PROJECT : ZU2
Quanta Computer Inc.

Size	Document Number	Rev
	Yonah/Merom CPU(POWER/GND)-2	1A
Date:	Thursday, March 22, 2007	Sheet 4 of 39

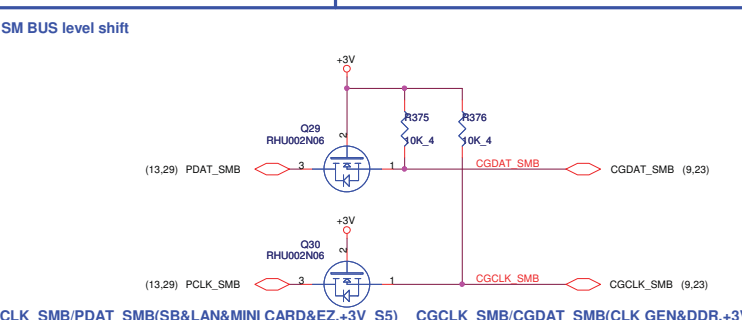
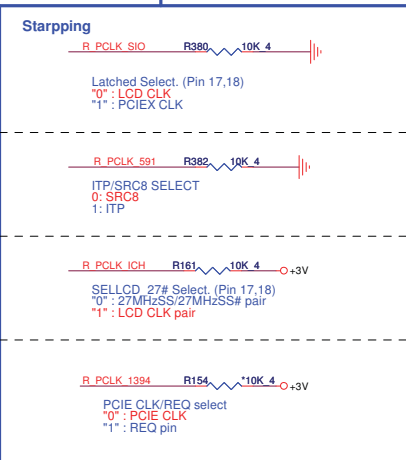
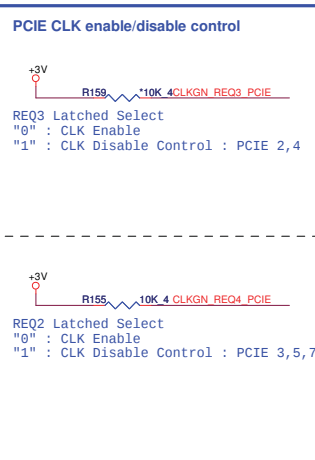
"EA report, fail in PCI_CLK_S0. It is too fast.
BOM change. R385 change to 33 ohm and unstuff R384."

LVDS

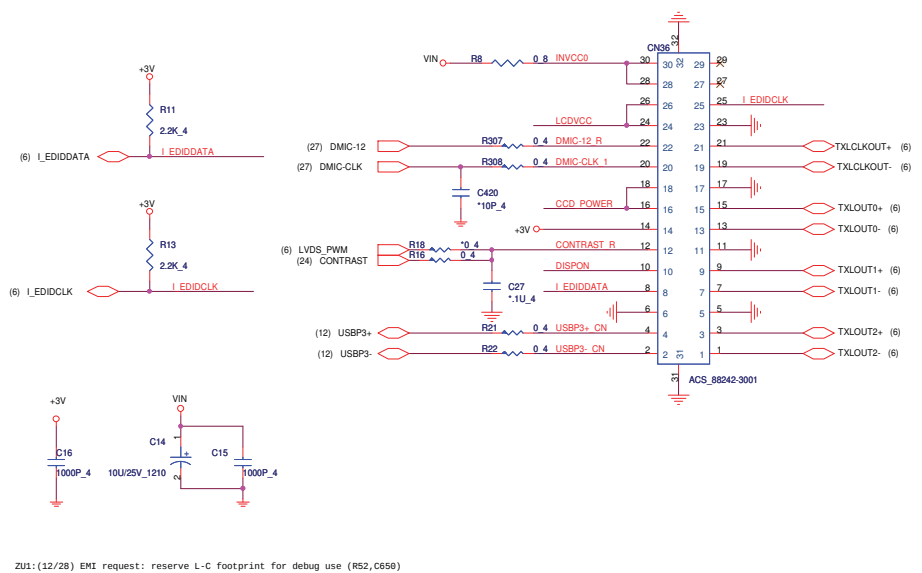
(3/19)Change MB LCD connector pin define(CN3) and LCD cable pin define to cover production line issue
(Inverter short with signal to burn system)->ZR1 issue
(1)pin 27,29->NC
(2)pin 8->INT_LVDS_EDIDDATA

LCD Power

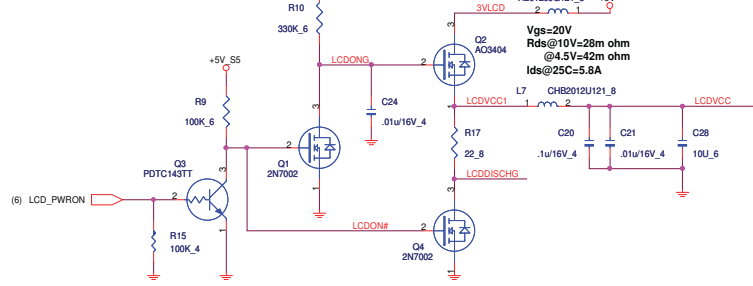
1/29:By Alan: AAT4280 fail on power ON rising time and falling time. EA.Additionally, some LCD panels will have garbage. follow ZR1 circuit.

CODEC (ALC268)

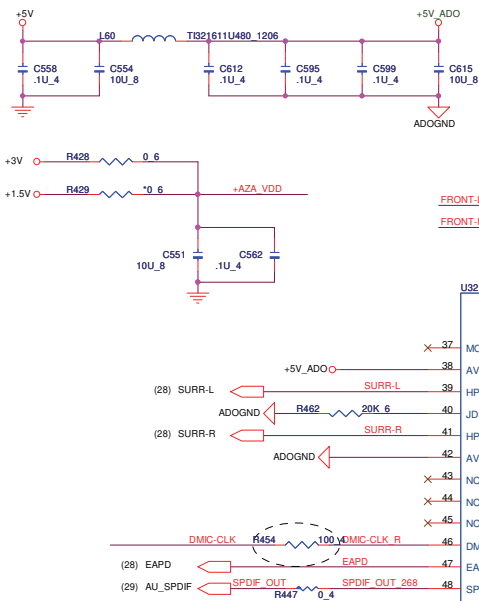
EMI suggest:
Add Additional two more bridge resistor
between ADDGND and GND,stuff R330 for Int-SPK issue

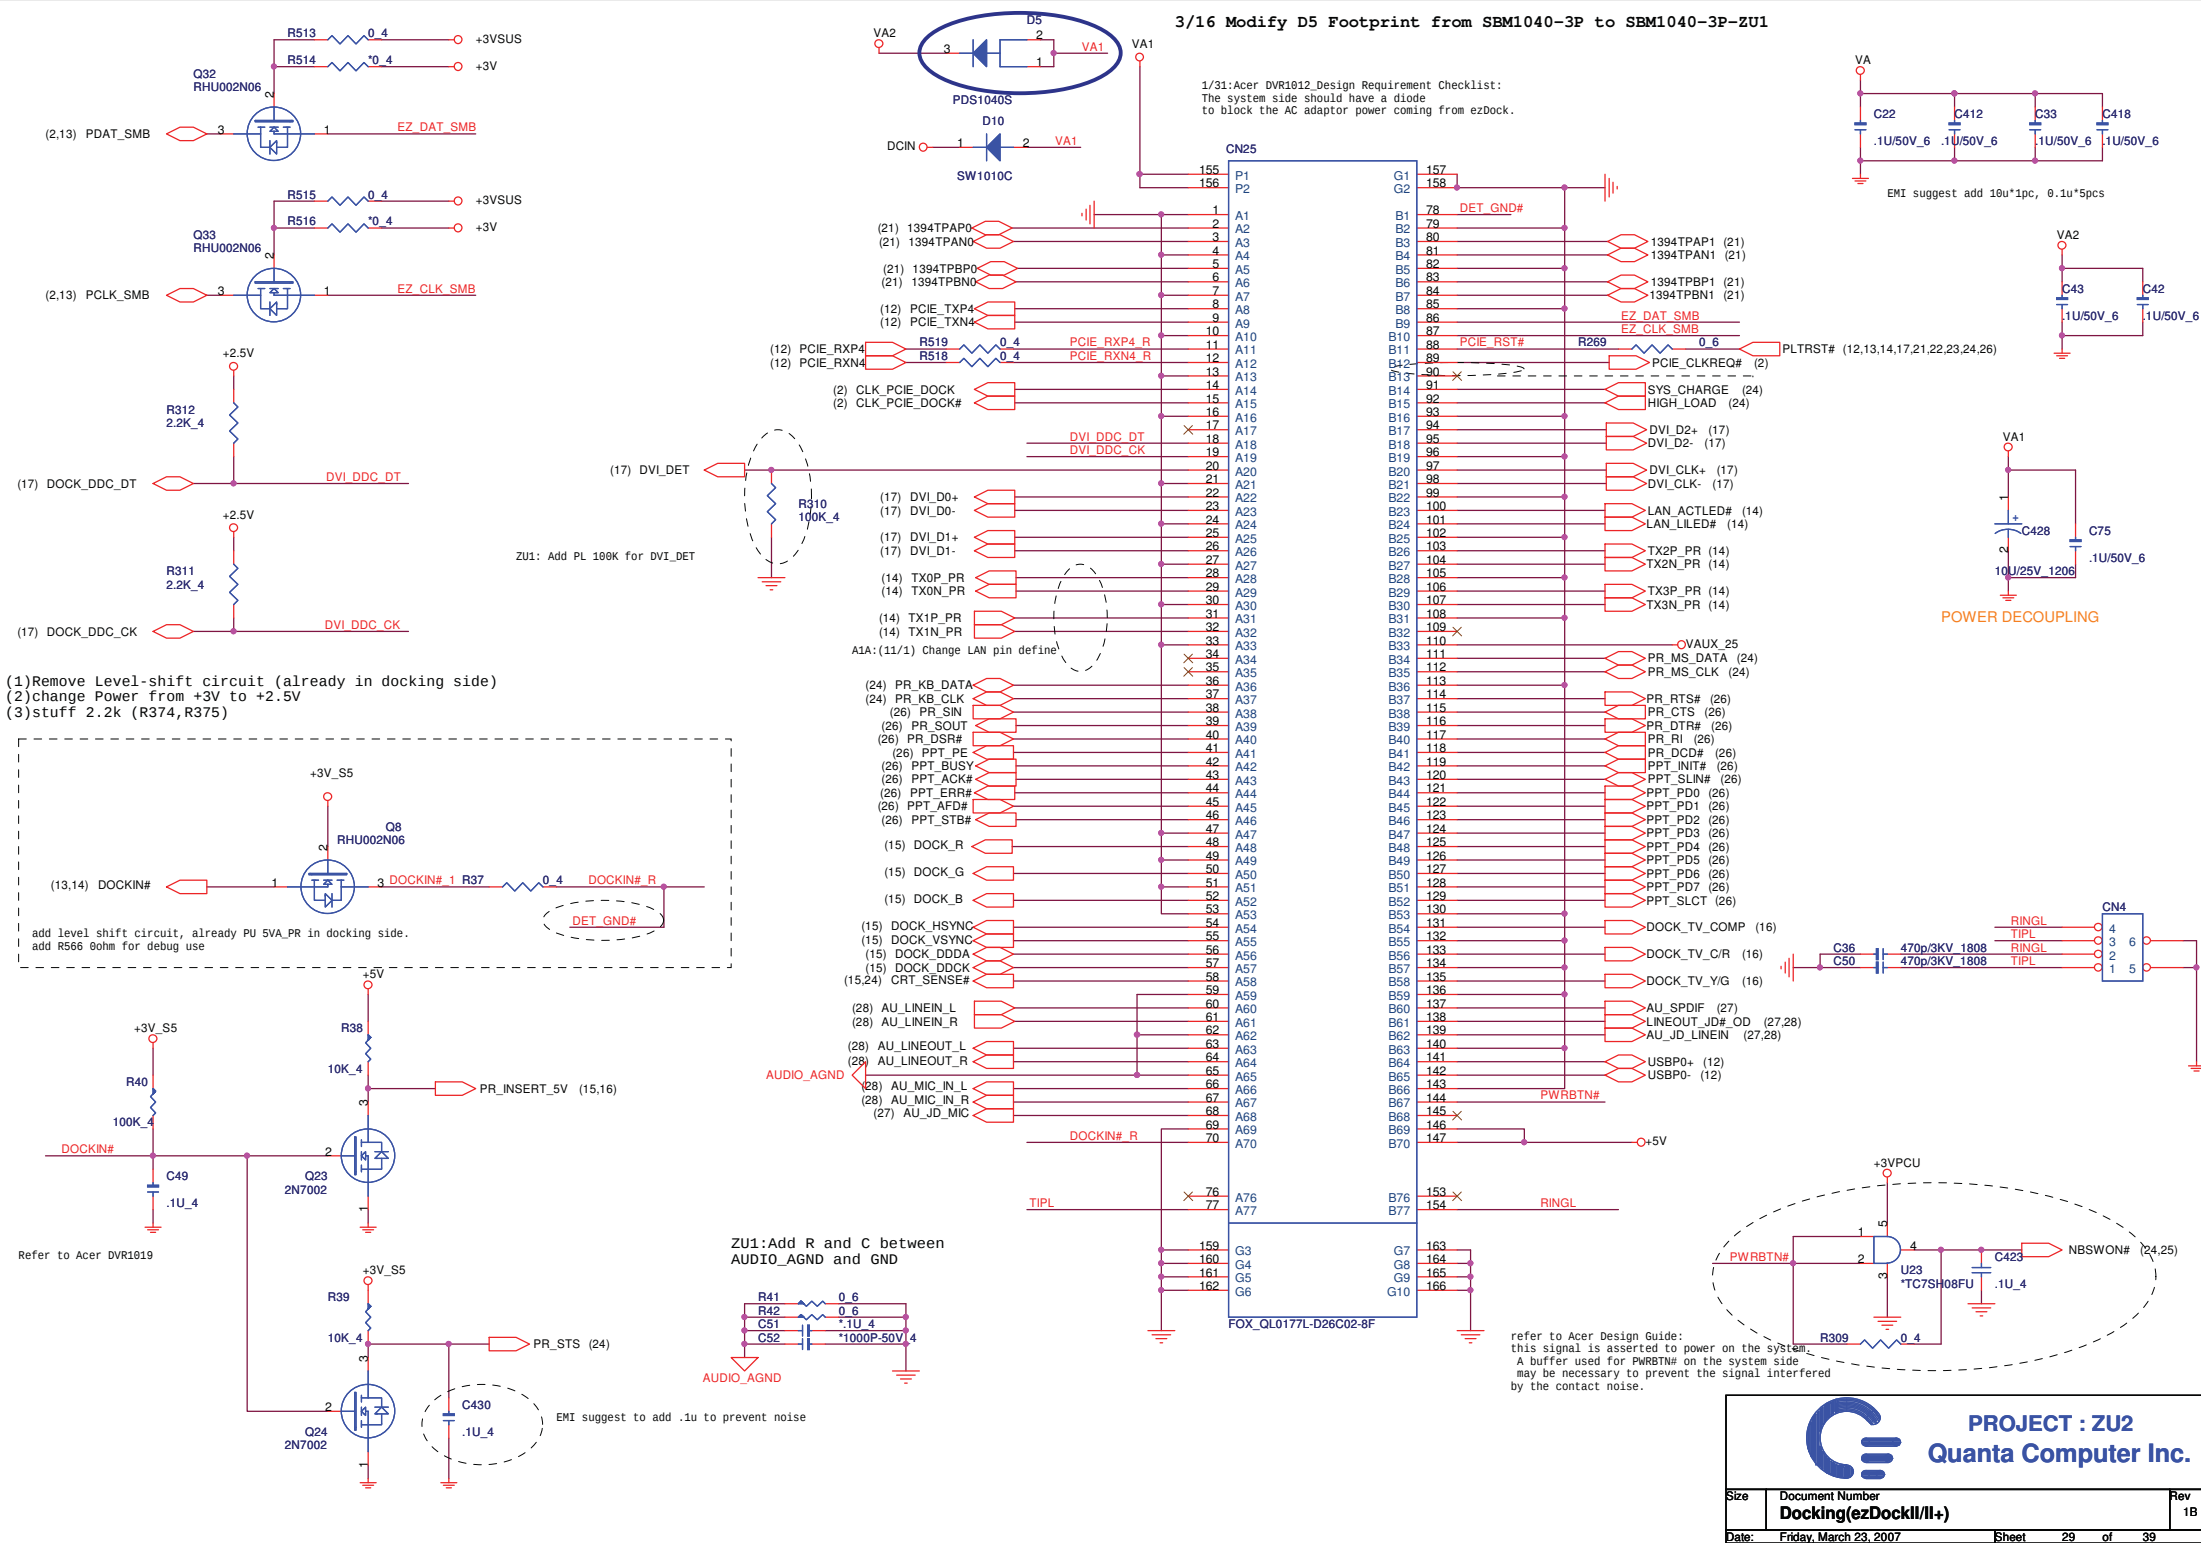
3/16 Modify D5 Footprint from SBM1040-3P to SBM1040-3P-ZU1

1/31: Acer DVR1012 Design Requirement Checklist:
The system side should have a diode to block the AC adaptor power coming from ezDock.

EMI suggest add 10u*1pc, 0.1u*5pcs

POWER DECOUPLING

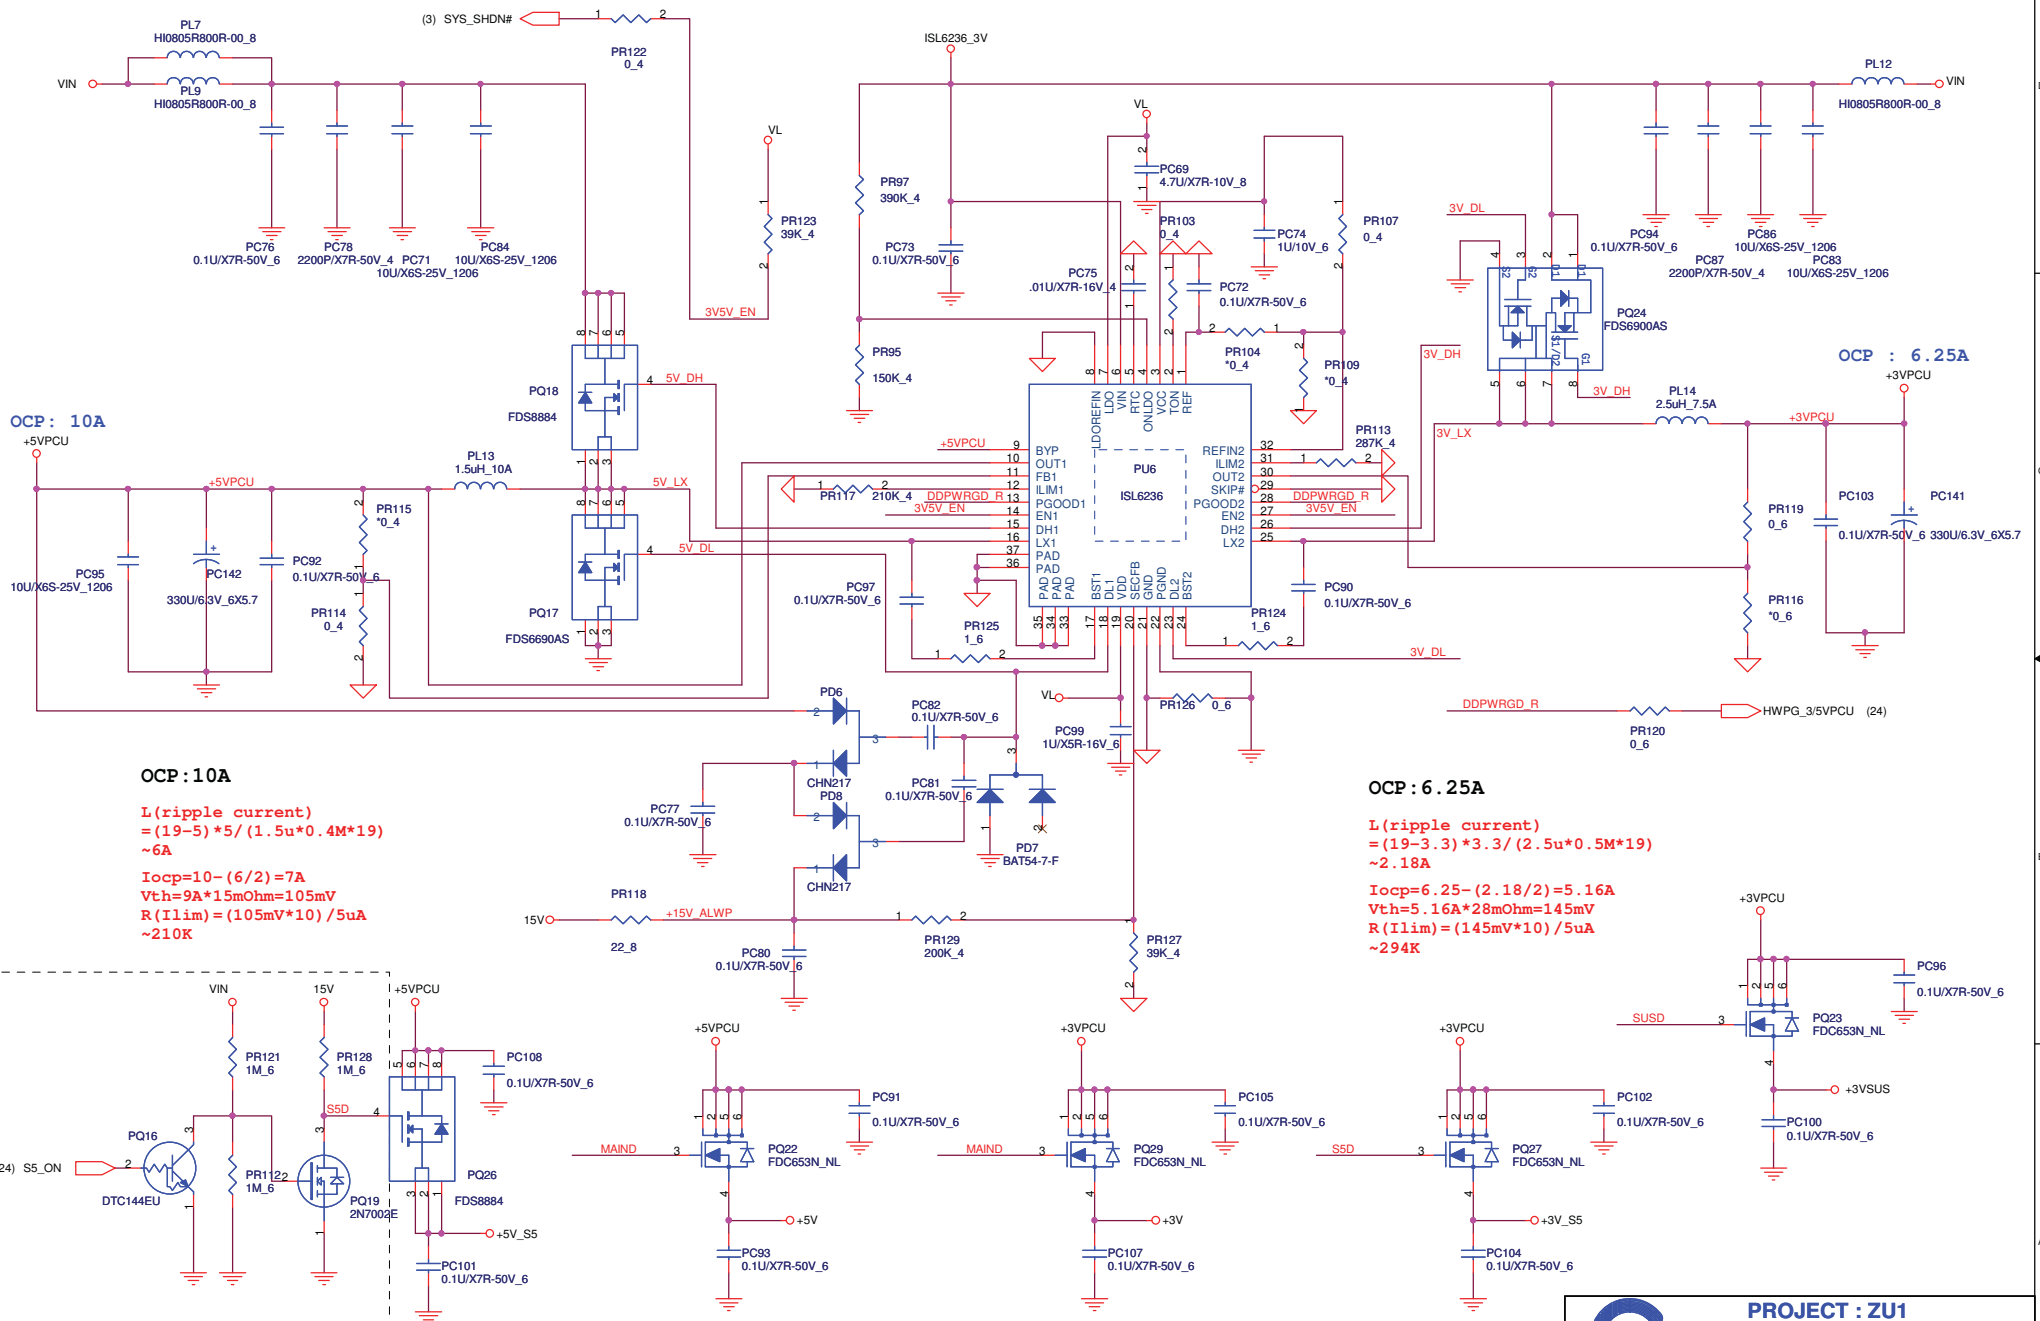
refer to Acer Design Guide:
this signal is asserted to power on the system.
A buffer used for PWRBTN# on the system side
may be necessary to prevent the signal interfered
by the contact noise.

C2A: (12/18) change S5_On control circuit

B1C: (11/29) change P26 from FDS6690AS (BAM6690022) to FDS8884 (BAM8884006)
